**Comanche Peak Nuclear Power Plant, Units 3 & 4
COL Application**

FSAR Revision 2

Update Tracking Report

Revision 1

Figure 13.1-203 CPNPP Units 3 and 4 Site Organization*

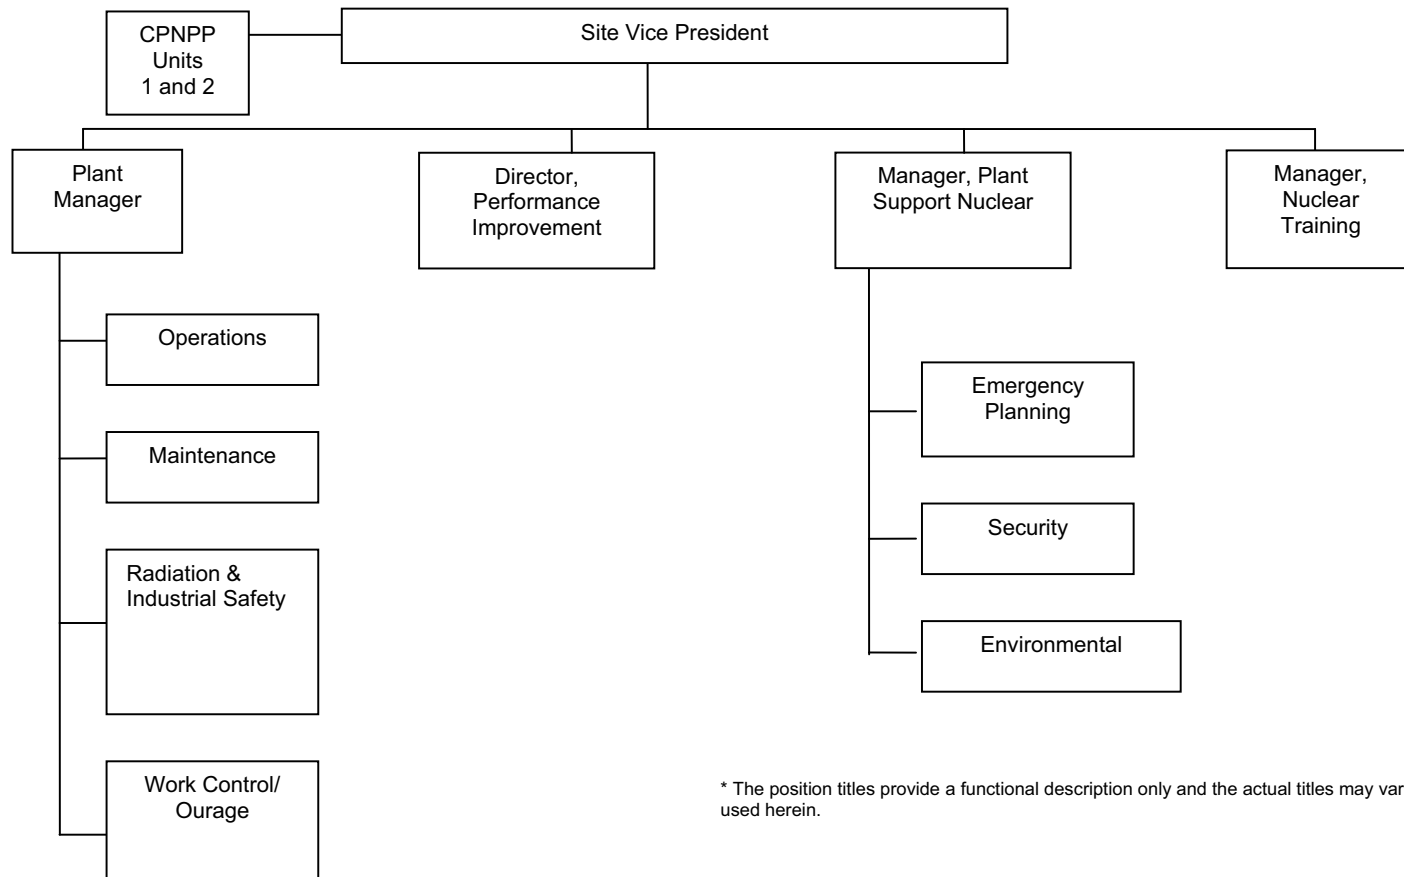
CTS-01393
